This document referring to working document ECE/TRANS/WP.29/GRRF/2014/23/Rev.2. The only changes concerning editorial mistake and the proposal submitted under Supplement scheme. The changes are highlighted in yellow.

Proposal for amendments Supplement 03 to the 02 series of amendments to Regulation No. 90 (Replacement brake linings)

- "3. **Brake disc design types for L₁, L₂, L₃, L₄ and L₅ categories** (examples)

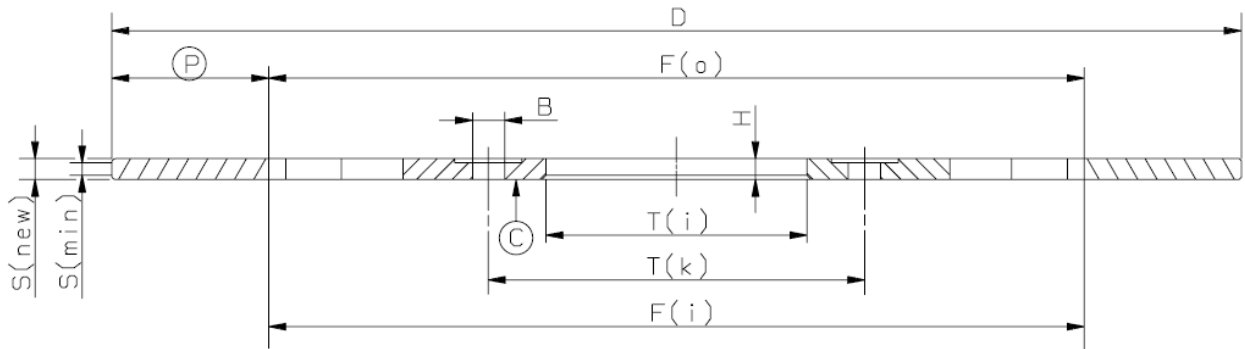
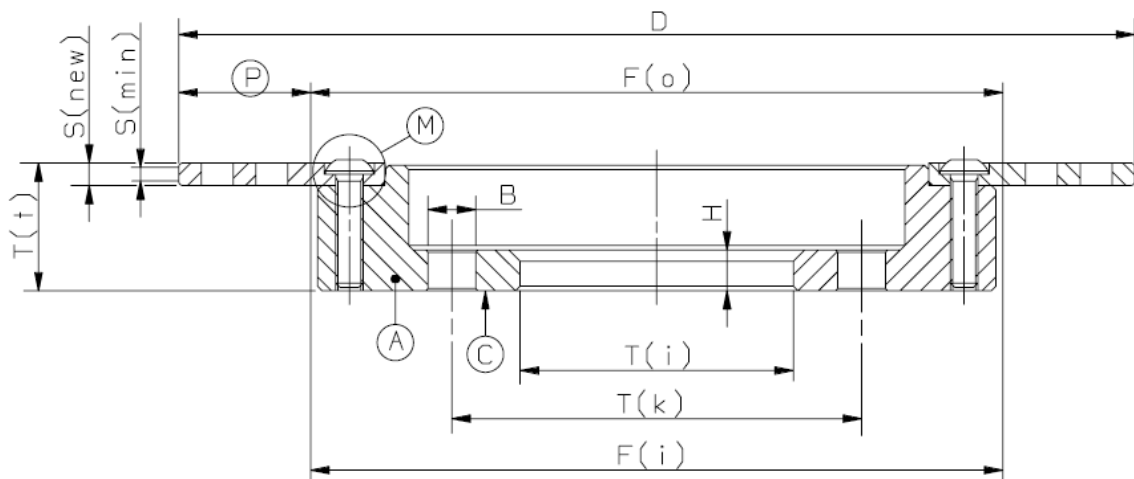
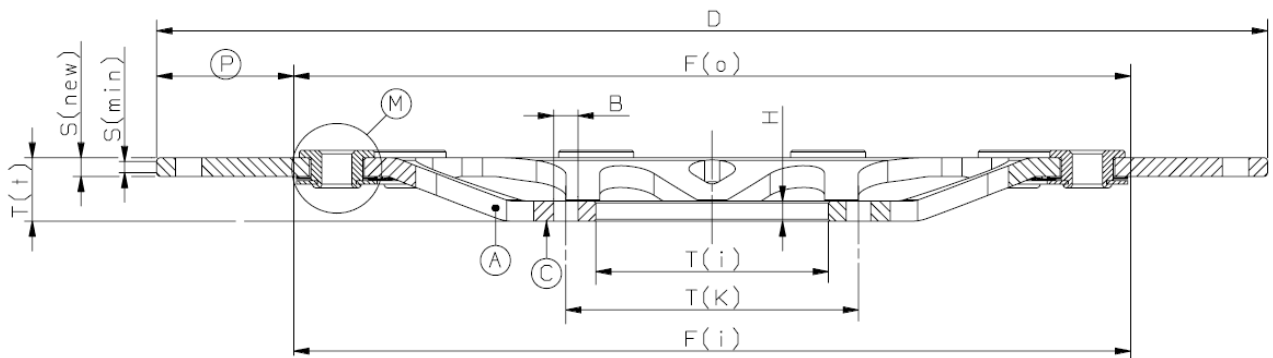
Add a new Paragraph 3., to read:

One-piece type: brake disc with braking surface and bell made in a single piece and, therefore, of the same material

Composed fixed type: brake disc having the braking ring made of steel, while the bell is of other material, generally aluminium; the 2 components are rigidly bounded by a screwed or riveted connection.

Floating type: brake disc having the braking ring radially released from the bell, in order to allow its thermal expansion.

Figure 1

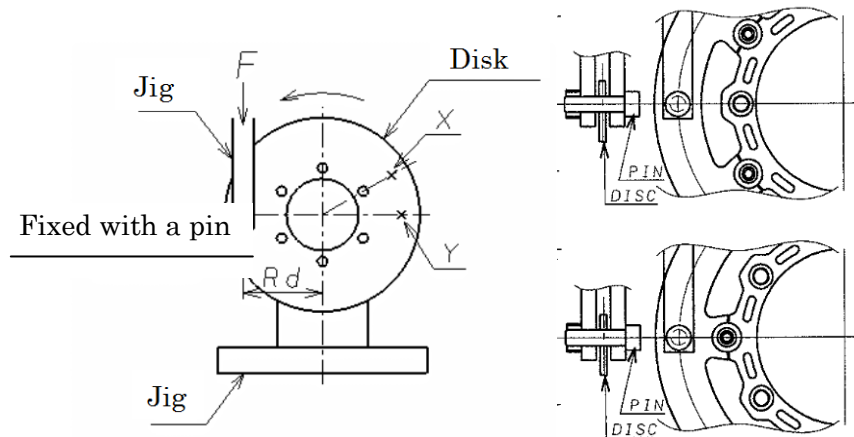
Static test performed on special test bench shown in Fig. 1.

Figure 2
Movement

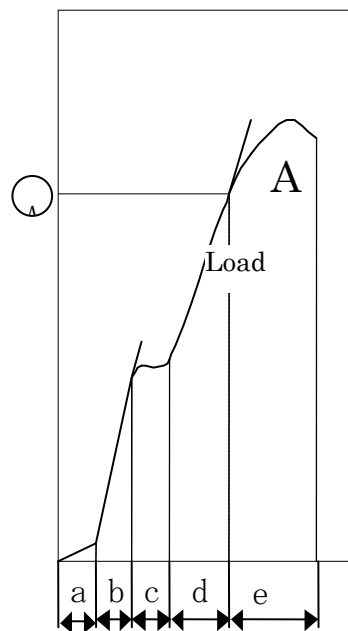
- (a) Adjustment stroke of the equipment (recovery of any clearance between the hole on the braking surface and the connection pin to the bench arm);
- (b) Load developed by the fastening screws to the equipment;
- (c) Movement of the brake disc caused by its rotation with sliding on the plate of the equipment, when the disc's fastening screws bear against the fixing holes of the disc;
- (d) Load supported by the brake disc;
- (e) Permanent deformation of the brake disc (starting from point A).

The disc ~~does not have to undergo~~ shall not have permanent deformations before reaching the force F specified in Table A14/2.2.5; the measurement of the deformation force must be performed at point A as in Fig.2.

Figure 3

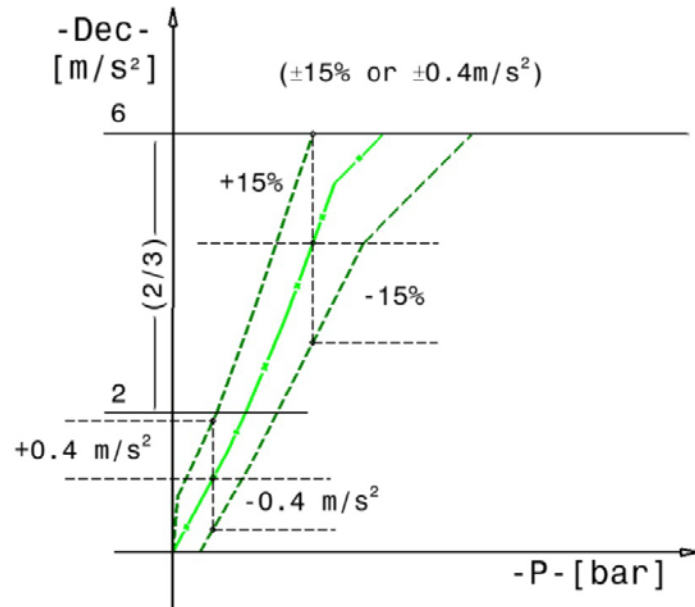
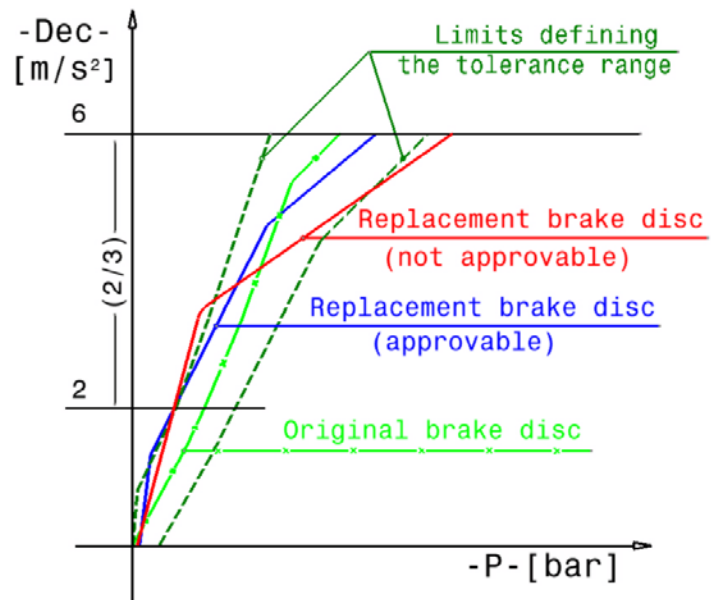
3.2.6.4. The dynamic frictional properties of the replacement brake disc can be regarded as similar to those of the original brake disc, provided the values attained in relation to the mean fully developed deceleration at the same operating pressures or control forces in the region of the upper 2/3 of the curve generated do not deviate by either ± 15 per cent or ± 0.4 m/s² from those of the original brake disc (see an example of the curve in Fig. 3 and Fig. 4).

Figure 2

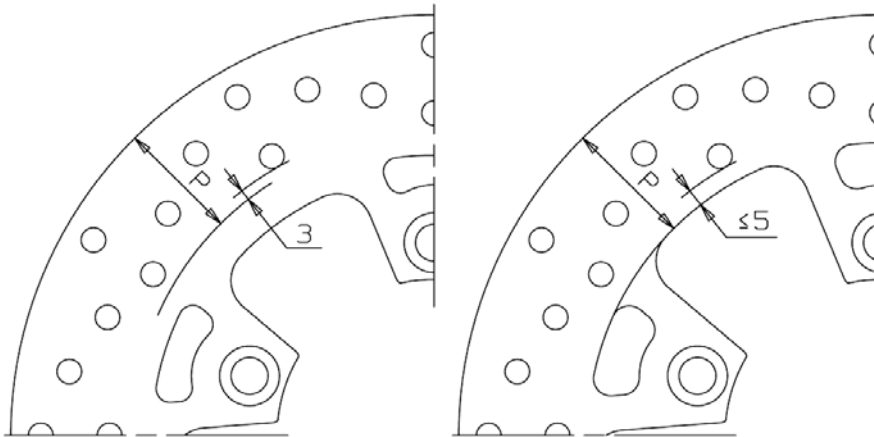
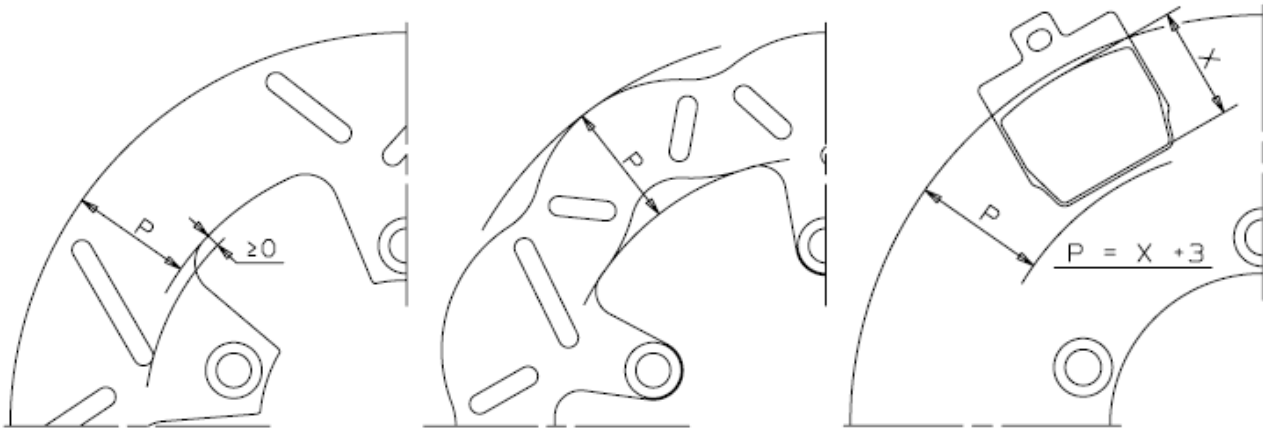
Braking surface means the surface of a brake disc on which the brake pads work. The braking surface width is calculated between the disc outer diameter and an internal diameter defined as follows:

- 1.1. Case of braking surface with lightening (holes, slots, wave, etc.) on the braking surface (Fig. 1) only: 3 mm towards the centre of the disc from the end of the lightening.**
- 1.2. Case of braking surface with lightening (holes, slots, wave, etc.) with distance from the disc's internal diameter lower than 5 mm (Fig. 2): diameter of the brake disc undercut.**
- 1.3. Case of braking surface with lightening (holes, slots, wave, etc.) which terminate inside, outside the brake disc undercut (Fig. 3): diameter of the brake disc internal undercut.**
- 1.4. All other cases: internal diameter defined by the radial width of the largest combinable pad, to which 3 mm need to be added (Fig. 4).**
